# 3rd Party API RBI Consequence Model Review

API RBI User Group Meeting  
Houston Marriott Greenspoint

Philip A. Henry  
October 5, 2006

# 3<sup>rd</sup> Party Consequence Review

- Two-Phase Releases

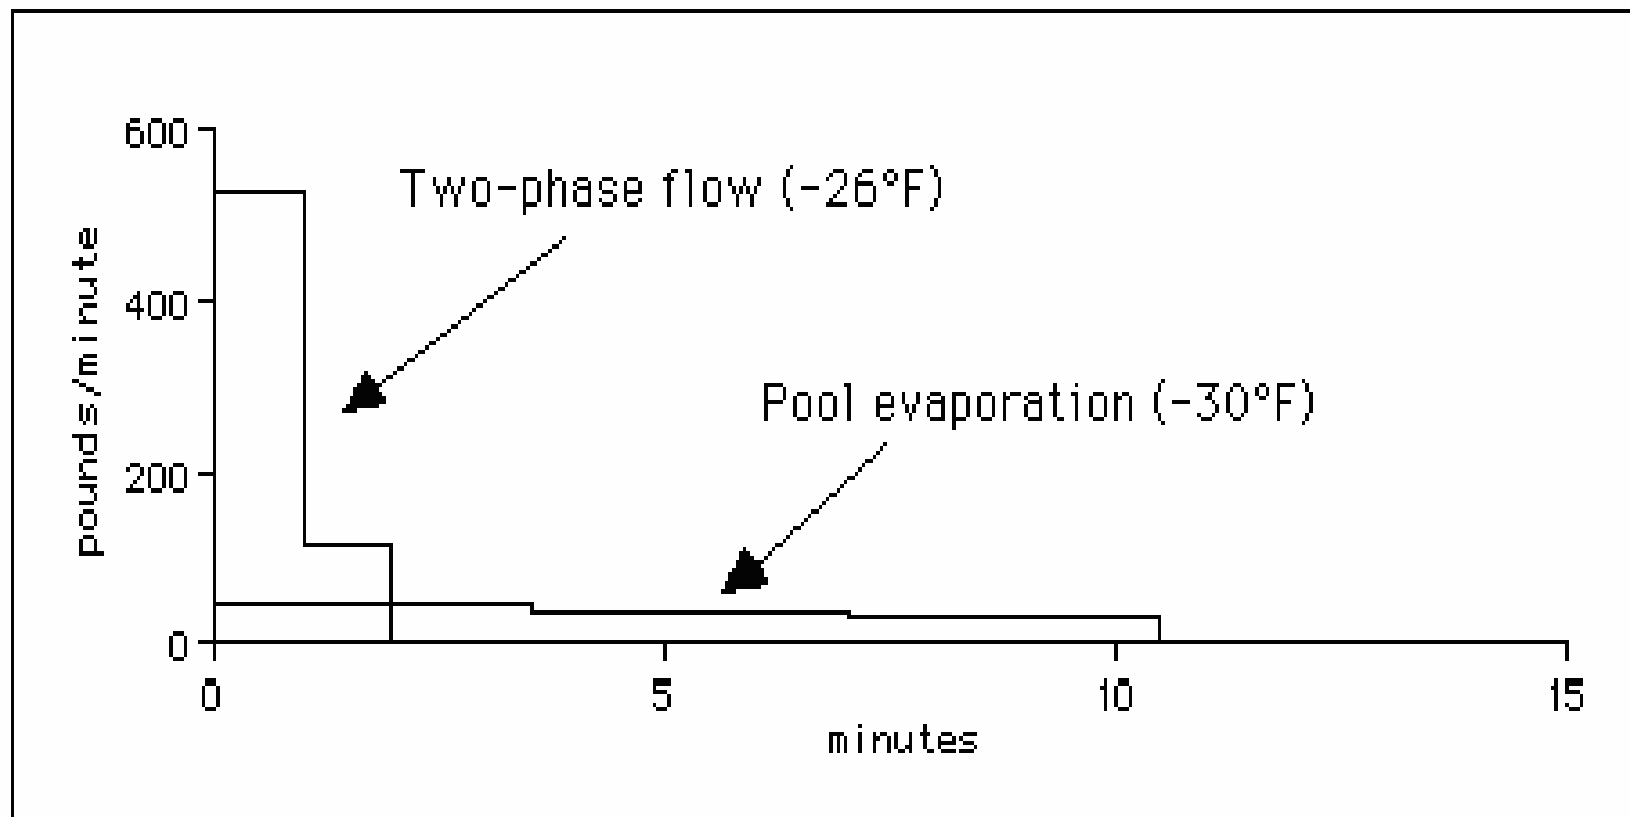
- LEVEL 2 COMMENTS
  - The step-by-step calculation procedures documented for Level 1 should be similarly documented for Level 2
  - Additional text with one or two examples is needed to show how mixtures are treated
    - How do we model vapor and liquid releases, same composition or ideal mixture
    - Cloud coming off of pool, properties used
  - Using the actual composition of a fluid in Level 2 rather than a representative fluid in Level 1 significantly improves the defensibility of the RBI assessment.
  - Two-phase releases should be modeled as two-phase releases only. No assumptions treating the release as a liquid only should be made. Potential inaccuracies are shown by the following figure for a chlorine release which contrasts the difference only a few degrees makes on the atmospheric source strengths (predicted by ALOHA 5.2) for two-phase flow and pool evaporation.

- LEVEL 2 COMMENTS (Con't)
  - Probabilities of ignition, MW curves versus flash point

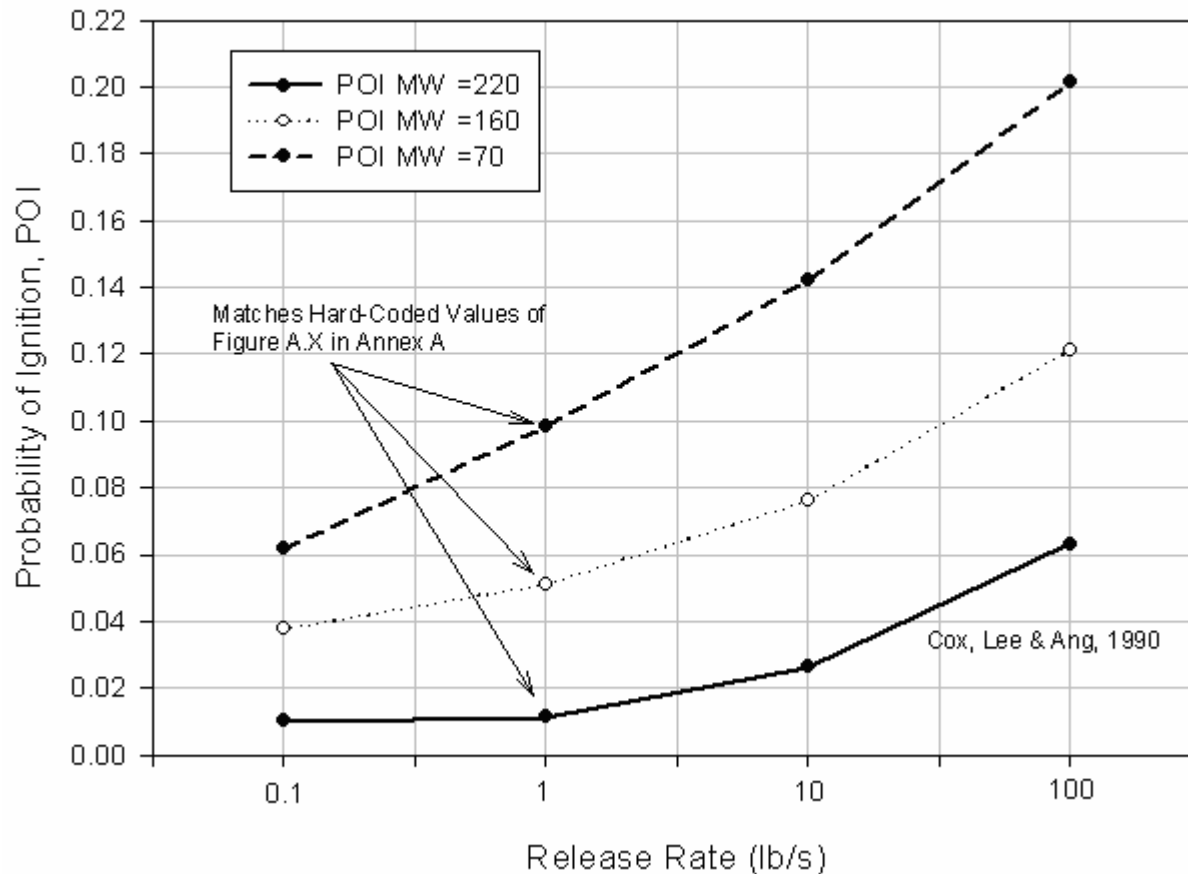
- LEVEL 2 COMMENTS (Con't)
  - The values for the probability of ignition employed in the event trees are a significant improvement over Level 1 and are consistent with current research. For example, the Energy Institute in the United Kingdom has performed extensive research on ignition probabilities and has published a number of reports on this topic. One report, *Ignition Probability Review, Model Development and Look-up Correlations*, 1st ed., Jan 2006, ISBN 978 0 85293 454 8, relates ignition probability to the mass release rate. The following figure shows how curves from their research are similar to the work of Cox, Lee, and Ang cited in Section 6.8.1.2.
